APPEAL SUMMARY

Appeal ID: 31463	Project Address: 3238 NE 20th Ave
Hearing Date: 4/12/23	Appellant Name: Dave Spitzer
Case No.: B-003	Appellant Phone: 503 335 9040
Appeal Type: Building	Plans Examiner/Inspector: Roza Malekzadeh
Project Type: residential	Stories: 2 Occupancy: R-3 Construction Type: V-B
Building/Business Name:	Fire Sprinklers: No
Appeal Involves: Erection of a new structure	LUR or Permit Application No.: 23-016760-RS
Plan Submitted Option: pdf [File 1]	Proposed use: adu

PAYNE GARAGE / ADU
3238 NE 20TH AVE
PORTLAND, OR

APPEAL DECISION

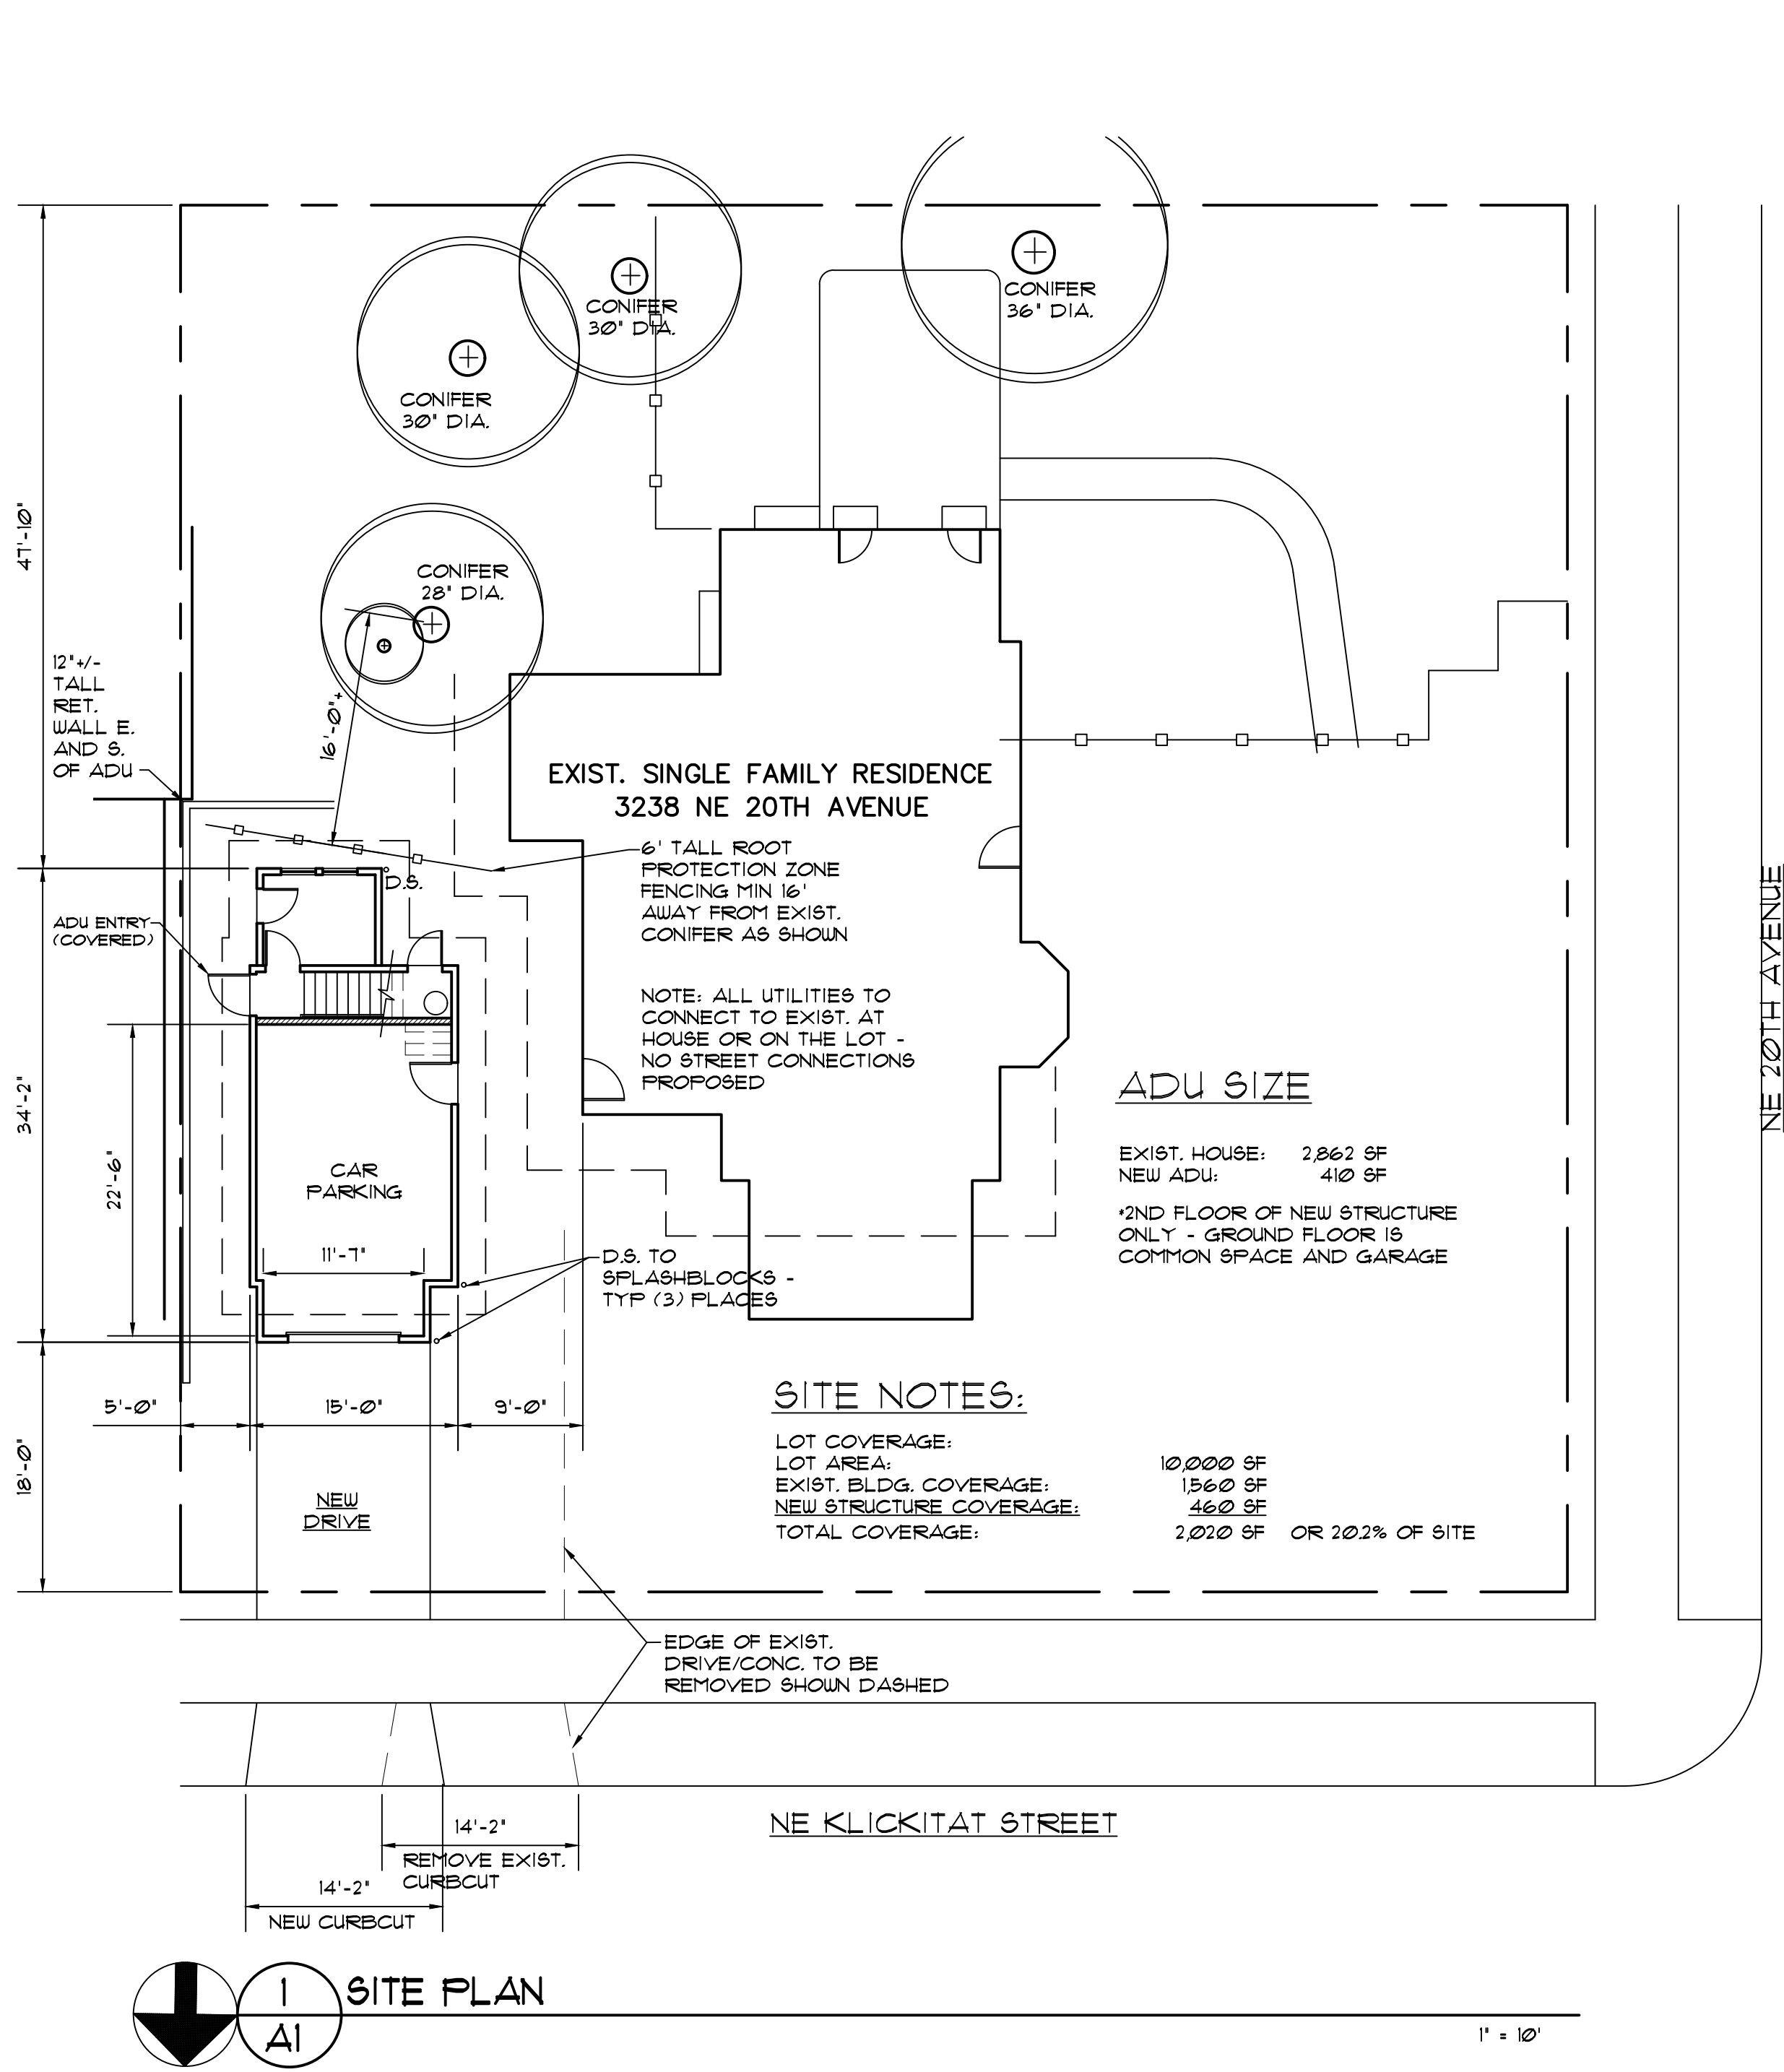
Code Section R302.3

Requires Requires eaves to be a minimum of 2' from the property line.

Code Modification or Alternate Requested We are requesting the new ADU to have fire rated eaves just 1' from the property line and to maintain the existing non-rated eaves of the house 2' from the property line.

Proposed Design The existing house has very deep - 4' wide eaves. The existing eaves are approximately 20' above grade.

We are building and ADU ontop of a garage (all new). We are in an historic district so using similar eaves to existing is important. While the existing house is very large and has 4' deep eaves - the new ADU structure is quite a bit smaller so 2' eaves are more appropriate.

We are also very tight on the site - as drawn our structure is only 15' wide - so loosing 1' for the eaves is important to make the space functional.

Instead of having our eave for the ADU 2' from the imaginary property line - we'd like to be just 1' but then install sprinkler heads at roughly 10' o.c. at the underside of the eaves were the two structures abut.

Reason for alternative The site is very tight, architectural compatibility in this historic neighborhood is very important as well. Providing (3) sprinkler heads at the underside of the ADU eaves (which is lower than the main house eaves) will provide protection for both structures.

Proposed ADU with reduction in the minimum required West eave fire separation distance from two feet to one foot with partial eave sprinkler protection: Granted provided 13D sprinklers are provided throughout the ADU with one head in garage near side door and provided fire resistant treated sheathing or Type X gyp sheathing is used beneath non-frt sheathing at West eave.
